**AGENDA ITEM:** **201401173** - 5188 & 5208 Roswell Road, *Applicant: Halpern Enterprises, Inc.*, to rezone the subject property from O-I (Office and Institutional District) conditional and R-3 (Single Family Dwelling District) to MIX (Mixed Use District) to allow for a mixed use office and residential development, with concurrent variances

Agenda Item: **201401173 5188 & 5208 Roswell Road, 141, 151, 161, 171 Mount Paran Road** a request to rezone the subject property from O-I (Office and Institutional District) and R-3 (Single Family Dwelling District) to MIX (Mixed Use District) to allow for a new office building, 11 single family homes and an existing 14,625 square foot building to remain, with concurrent variances.

#### DEPARTMENT OF COMMUNITY DEVELOPMENT RECOMMENDATION

HALPERN ENTERPRISES, INC. - Mt. Paran Rd. & Roswell Rd. (Site Plan)  
11 JUNE 2014

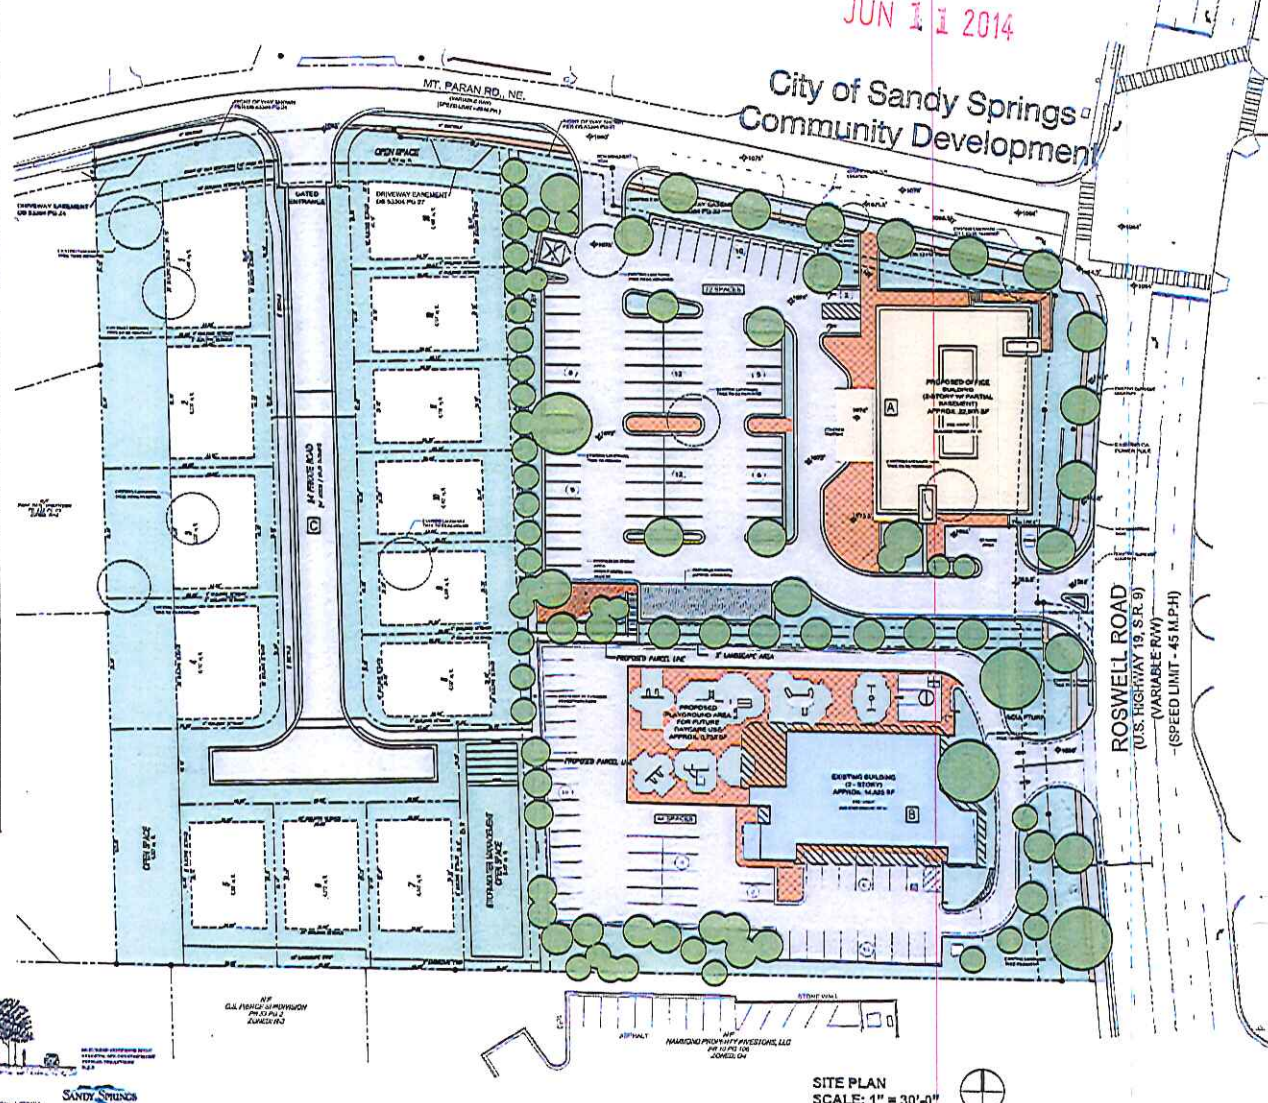
In general we believe the proposed residential portion of the development lacks an adequate buffer, is comprised of homes of an excessive height and is far too dense for a Sandy Springs single family home development. The density of homes abutting the Park Gate property lines should be significantly lower than the proposed increase of 233%. We believe there should be the requisite 50 ft buffer and 10 ft improvement setback as defined in the Sandy Springs Zoning Ordinance. In addition we would like to see a permanently planted landscape berm with mutually acceptable trees and shrubs in the buffer zone.

The current plan proposes 15 homes on 2.18 acres. This plan does not provide the required 50' buffers or 10' improvement setbacks that are required in all residential districts in Sandy Springs. This density is further exacerbated by the height of the proposed homes. This height increase is not only an issue for Park Gate Court but will also be an issue for some homes on Mt. Paran Road and Silverwood Road. The height of the homes should not exceed 40' or the project cannot be supported.

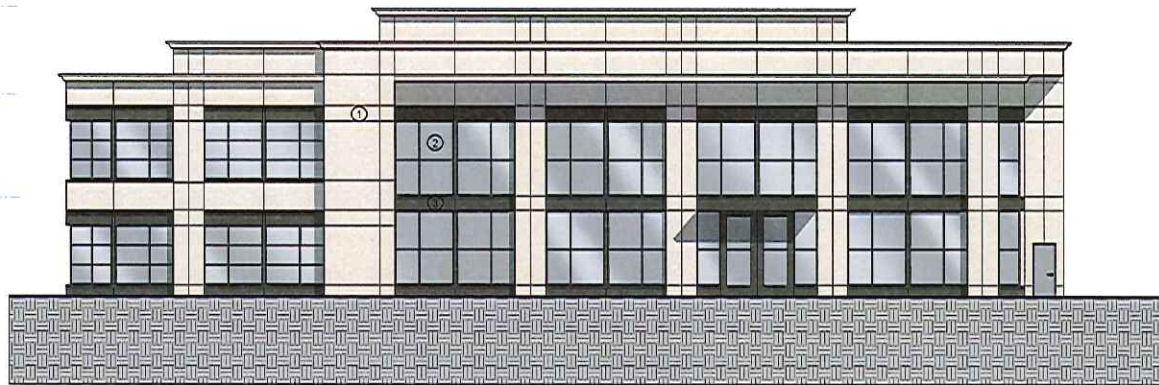
We believe the proposed office building at the corner of Mt. Paran and Roswell should be consistent with the surrounding neighborhoods and have a more traditional rather than modern appearance. We would like to understand more of the details surrounding the proposed daycare facility. Is the development contingent on the daycare facility taking the space? Where will the playground be situated and how will it be screened or buffered from the east side of the proposed residential development? We would like to see whatever is planned for this facility to be part of the rezoning rather than a private arrangement.

1. The proposed new 25,000 square foot commercial building needs to be redesigned to use compatible neighborhood scale architecture as stated in the Glenridge Node requirements where this building is located. We will need to know the new proposed elevations as this is not noted on the current site plan.

2. The proposed commercial building needs to be redesigned to fit in with the look of the neighborhood with a more traditional, upscale feel instead of the current glass, modern, downtown look in the plans.

Specifically, we are pleased to enclose a site plan dated July 28, 2014. As you will note, this plan is substantially similar to the site plan that we filed in connection with the Application on July 11, with the exceptions being that the location of the proposed Mount Paran driveway for the project was moved slightly to the east (closer to Roswell Road), to improve distance from the Park Gate subdivision driveway, and the proposed new office building was expanded slightly to follow the angle of the Mount Paran right of way. Additionally, after considering further comments from adjacent and area community members concerning the aesthetic impact of the proposed new office building, we are submitting revised office building elevations.
